SUBJECT: Forwards addl info per NRC 821210 request re Generic Ltr reactor vessel level instrumentation sys completed. Sys installation 30% complete.

H. B. ROBINSON STEAM ELECTRIC PLANT, UNIT NO. 2
DOCKET NO. 50-261
LICENSE NO. DPR-23
INADEQUATE CORE COOLING INSTRUMENTATION
SYSTEM (GENERIC LETTER 82-28)

Checklist for Plant Specific Review of
Inadequate Core Cooling (ICC) Instrumentation System

FIGURE 1. DISTRIBUTION OF FLUX THIMBLES AND THERMOCPLS.

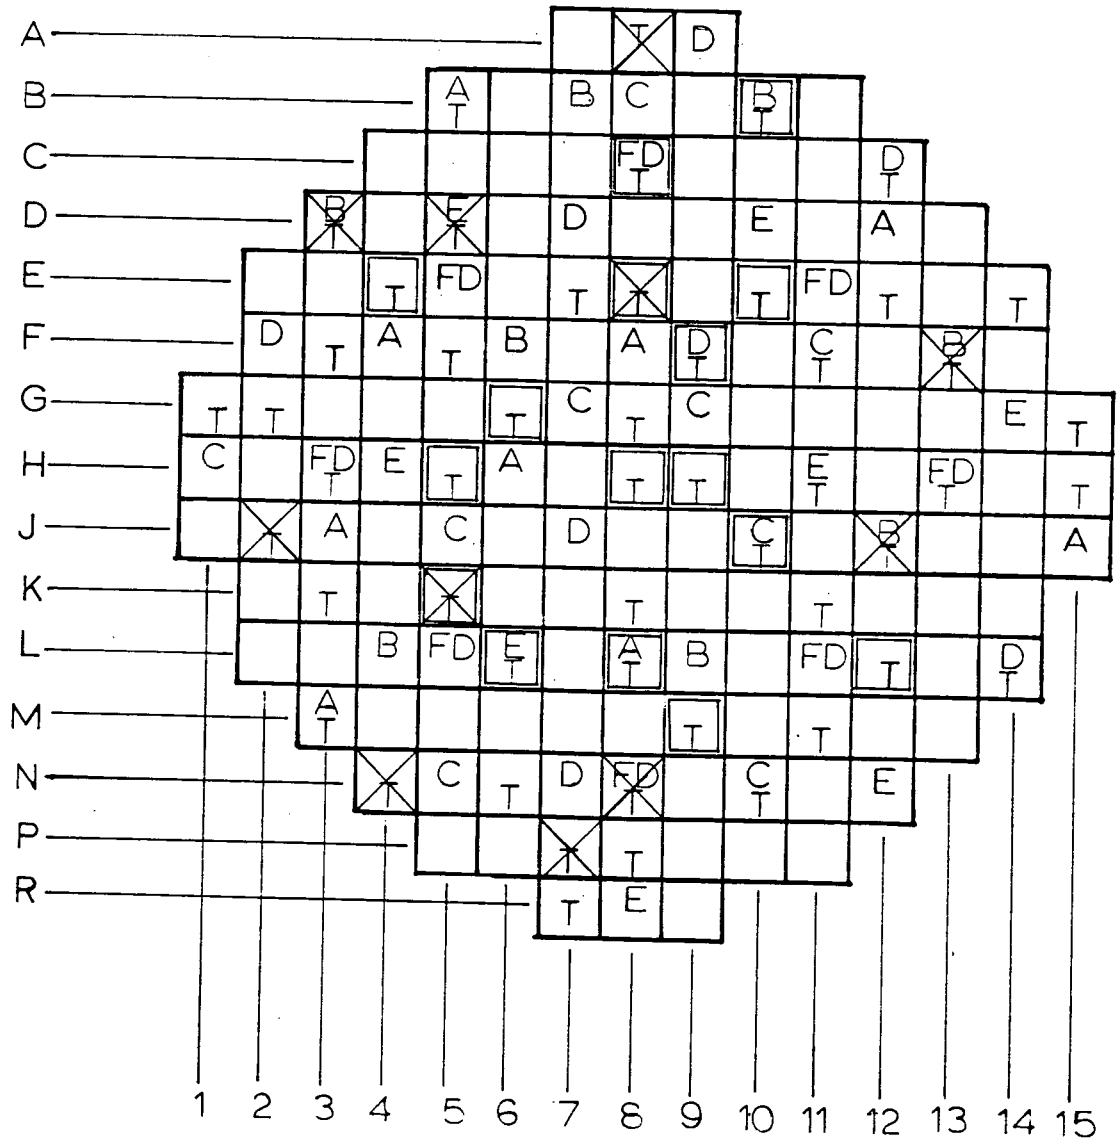
1. Provide diagram of core-exit thermocouple locations

The Core Cooling Monitor is described in detail in our letter, Serial No. GD-79-3306, dated December 31, 1979, and in our letter, Serial No. NO-81-569, dated March 31, 1981. The Core Cooling Monitor for HBR2 is installed and operational at the present time. The Core Cooling Monitor Thermocouple locations are shown in Figure 1.

The location of the Core-Exit Thermocouples is identified in Figure 1.

FIGURE 2.

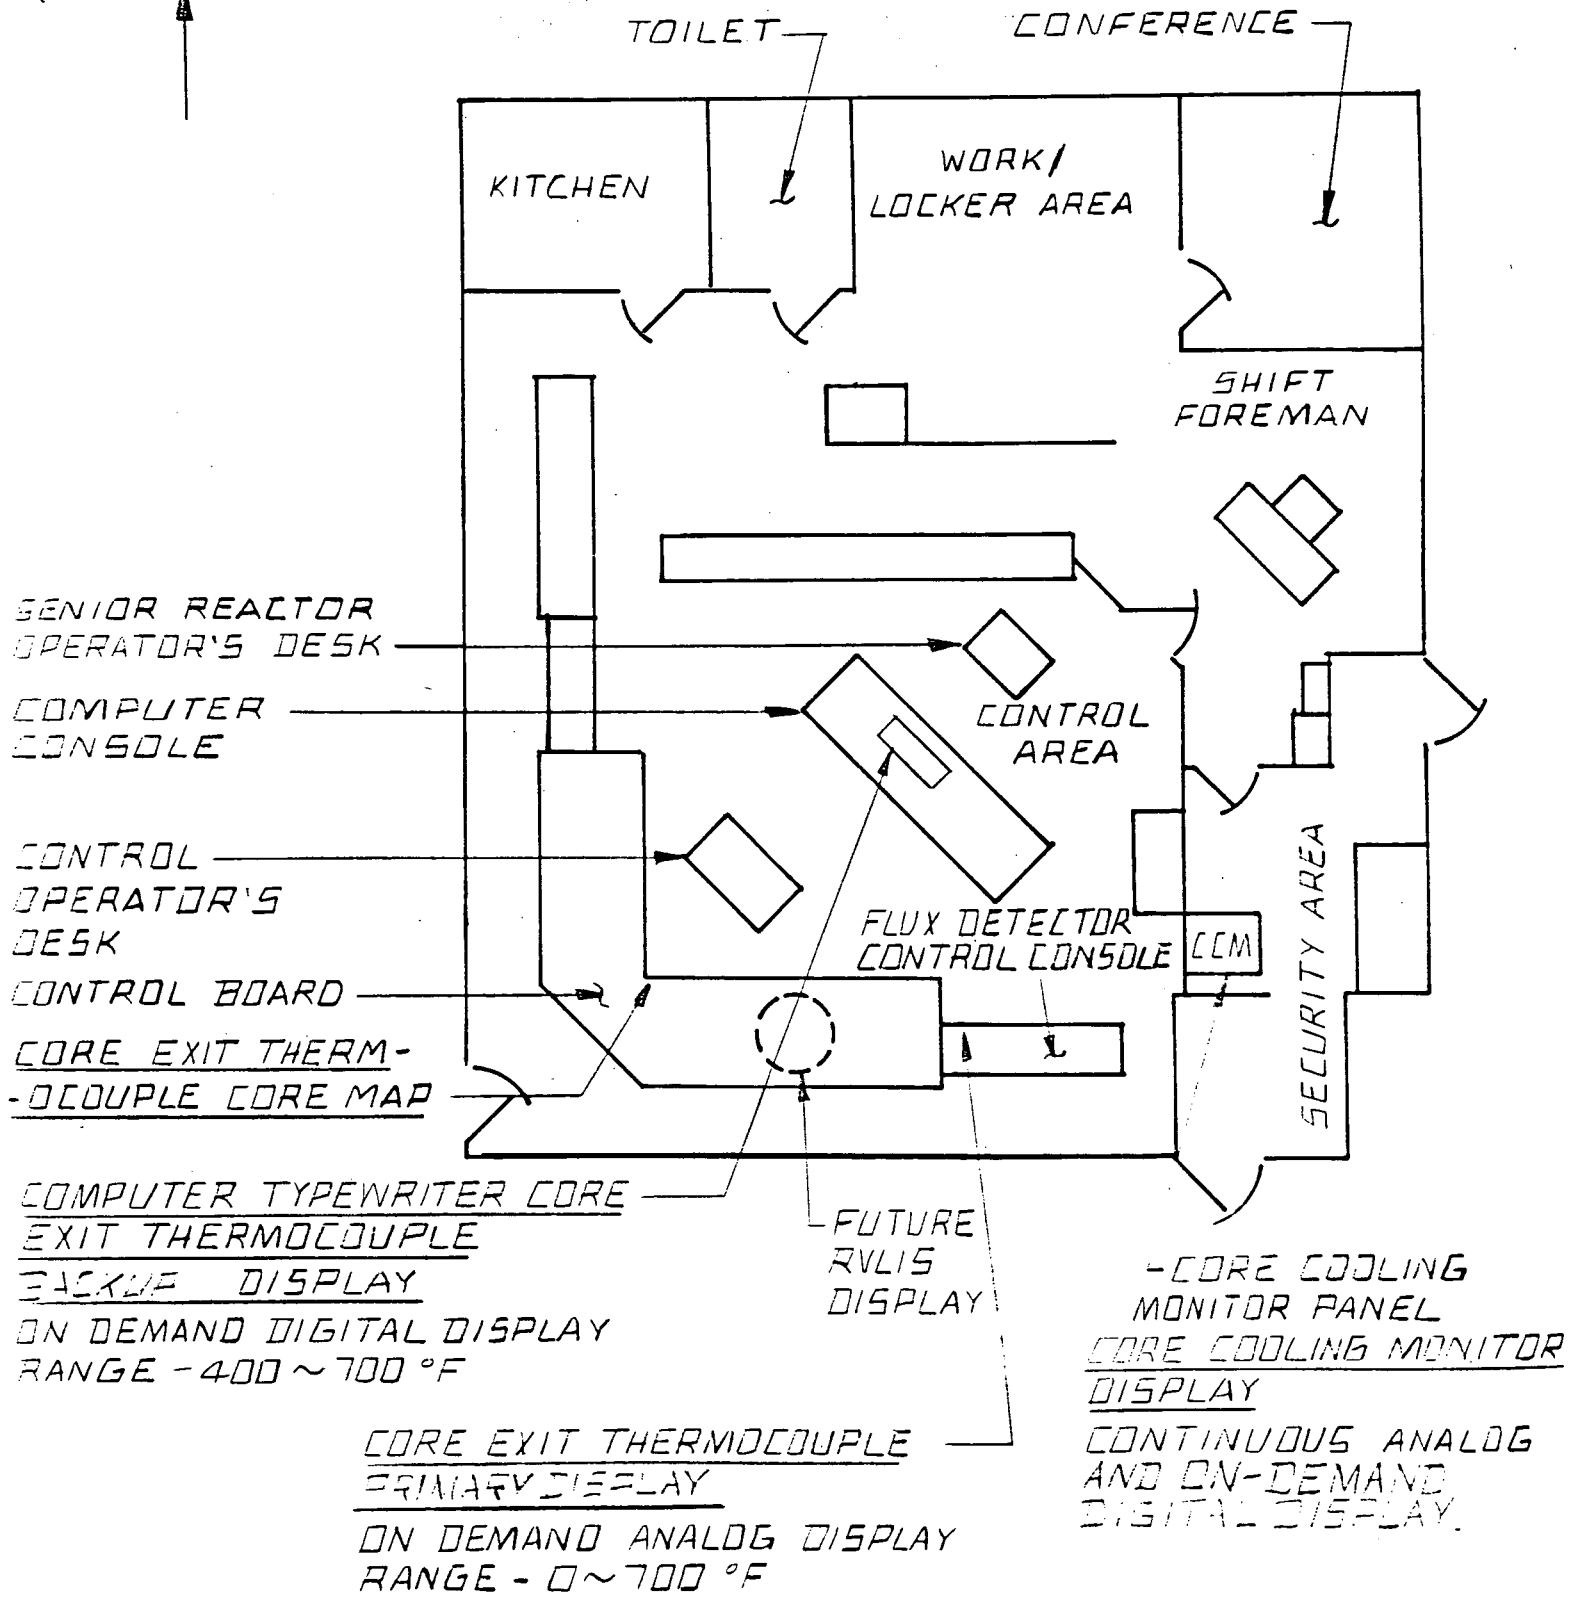
2. Provide a description of the primary operator displays including:
 - a. A diagram of the display panel layout for the core map and description of how it is implemented, e.g. hardware or CRT display.

2.d. Describe how the ICC instrumentation readouts are arranged with respect to each other.

A diagram of the layout of ICC instrumentation, including the Core-Exit Thermocouple System, is provided in Figure 2.

See Figure 2 for detailed location of ICC instrumentation.
